Technical Service Information

THM 200-4R NEW FILTER

Figure 1

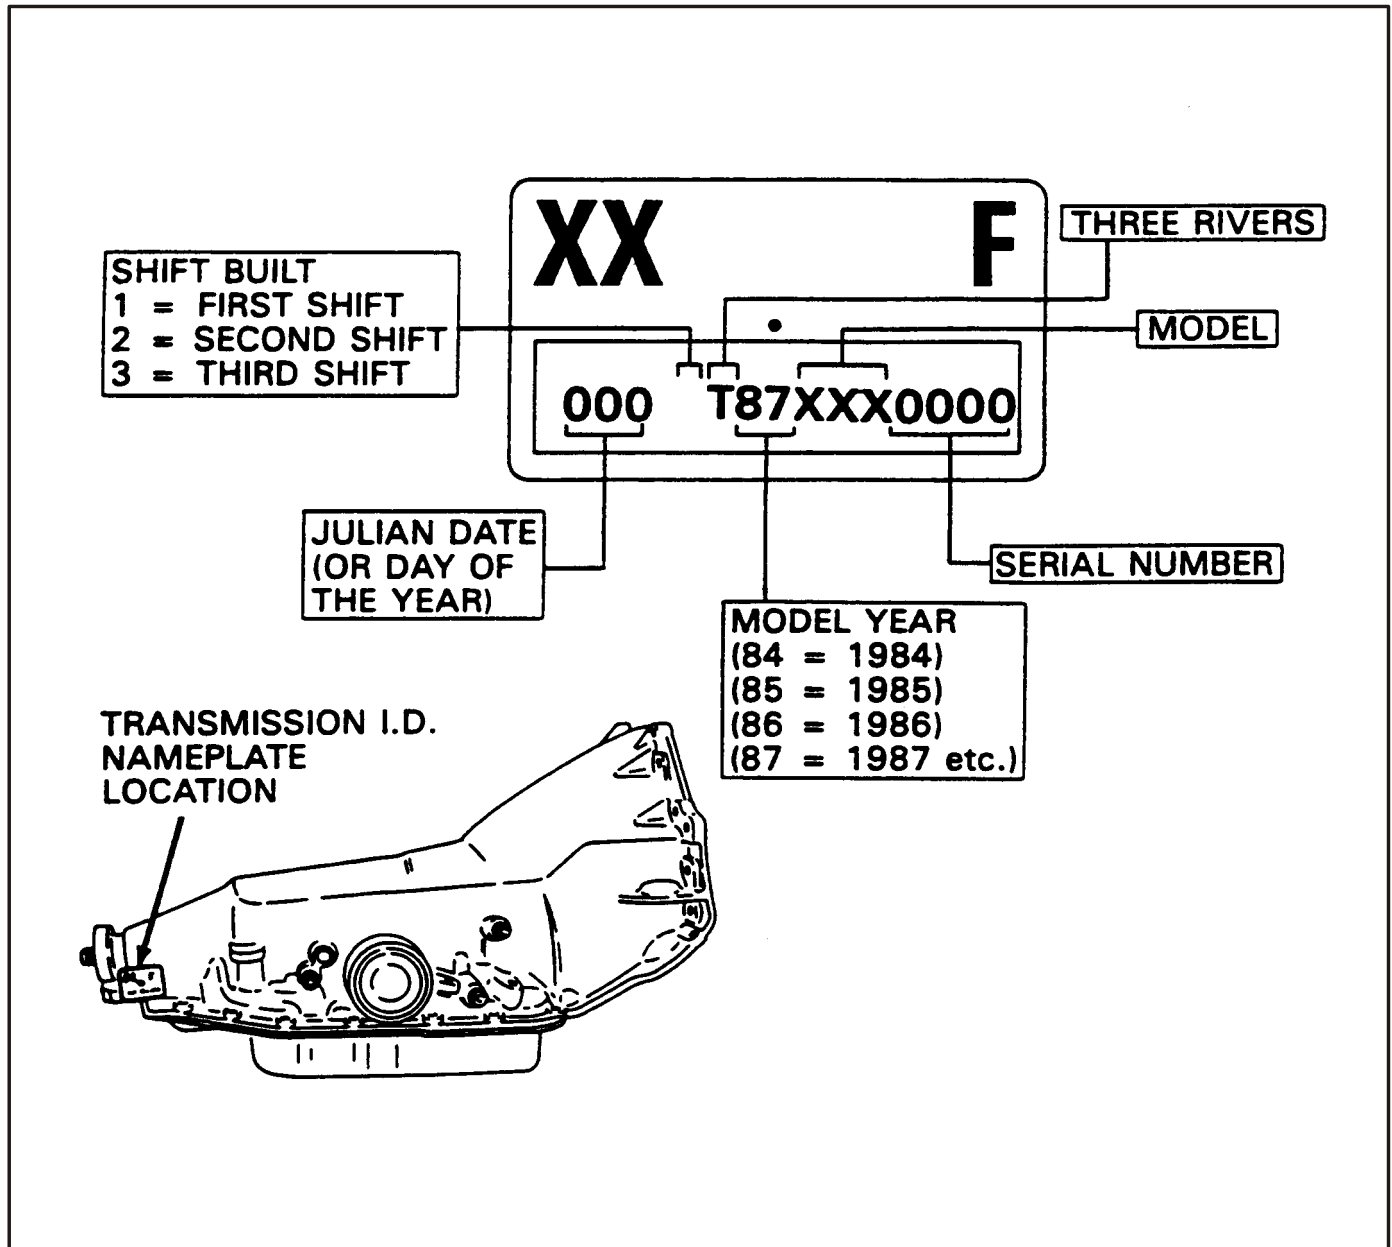
TRANSMISSION IDENTIFICATION INFORMATION (Figure 1) Note that the specifications given in this bulletin are at low end of the range printed in the service manual and only need to be used to correct a 1st/2nd gear noise condition.
